Docket Number:	23-AFC-01
Project Title:	Morton Bay Geothermal Project (MBGP)
TN #:	253188
Document Title:	Morton Bay Geothermal Project Revised General Arrangement Refinement
Description:	N/A
Filer:	Lindsey Xayachack
Organization:	Jacobs
Submitter Role:	Applicant Consultant
Submission Date:	11/17/2023 12:23:19 PM
Docketed Date:	11/17/2023

Revised General Arrangement Refinement

Morton Bay Geothermal Project
(23-AFC-01)
November 17, 2023

Figure 2-1R
General Arrangement,
Morton Bay Geothermal Project
Imperial County, California

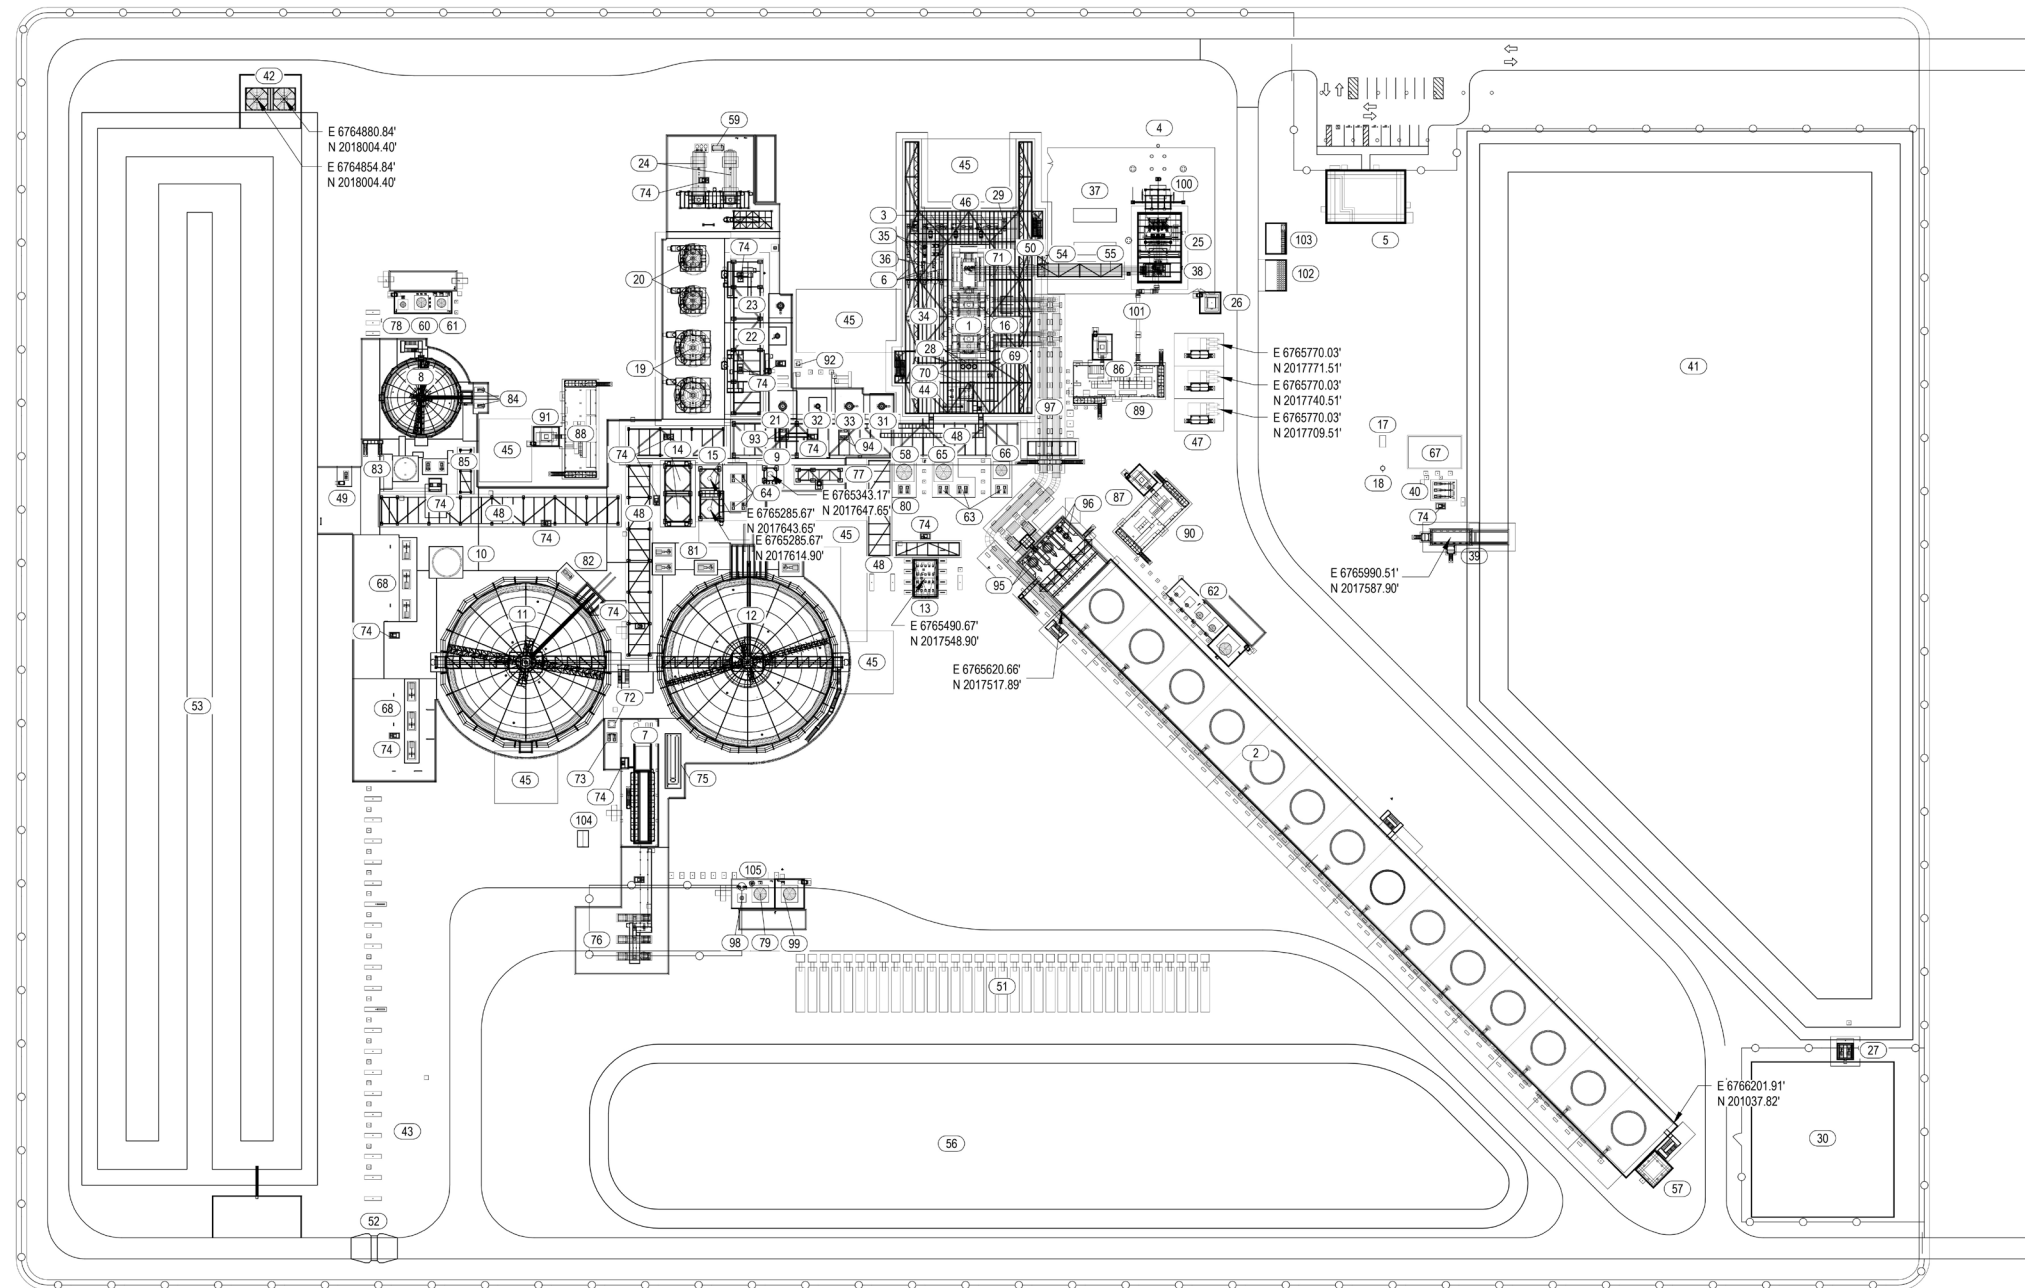
- **Reduced Number of Emergency Diesel Generators:** The number of generators has decreased from 4 to 3 due to updated operational electrical load information. The generators have been relocated nearer to the medium voltage bus to optimize the design and reduce quantities.

- **Stormwater Retention Basin – Relocated** to be more central to the project site.
- **Change to Storage of Hydrochloric acid (HCL):** change amount of hydrochloric acid (HCL) stored on site from 1,250 gallons of 37% HCL to one, 800-gallon tank of dilute HCL (2.5%) and one, 20,000-gallon tank of concentrated HCL (<37%). Included a HCL scrubbing system on both HCL tanks.

- **Addition of a 10,300 gallon tank of liquid lime (42-47% Calcium Hydroxide),** used for pH adjustment of the filtrate from Horizontal Belt Filter.
- **Horizontal Belt Filter-** Relocated the belt filter and optimized the truck hauling path to allow for a pull through design and reduced pipe rack length and piping runs.

- **Combination of Admin/Warehouse –** The admin/control buildings were relocated to allow for greater onsite security allowing for public access and parking outside of the fence line.

- **Power Distribution Centers –** Optimized Power Distribution Centers locations due to updated load locations
- **Cooling Tower –** The cooling tower design changed from two, seven cell towers to a single 14 cell tower.

- **Primary/Secondary Clarifiers –** The clarifiers arrangements were optimized to reduce concrete, pipe rack, piping, and electrical quantities.
- **HP Separators, SP and LP Crystallizers –** Optimized the centerlines of the HP separators and brought the crystallizers in line to reduce pipe rack quantities.

- **Gas Removal System –** The gas removal system was relocated to below the steam turbine to utilize the space below the steam turbine.
- **Thickener –** The thickener was relocated closer to the brine handling process to reduce construction costs.

- **Evapotranspiration Bed –** The evapotranspiration bed location was relocated closer to the control building.
- **Chemical Storage –** Chemical storage locations were optimized for safe loading/unloading and pull through routes.
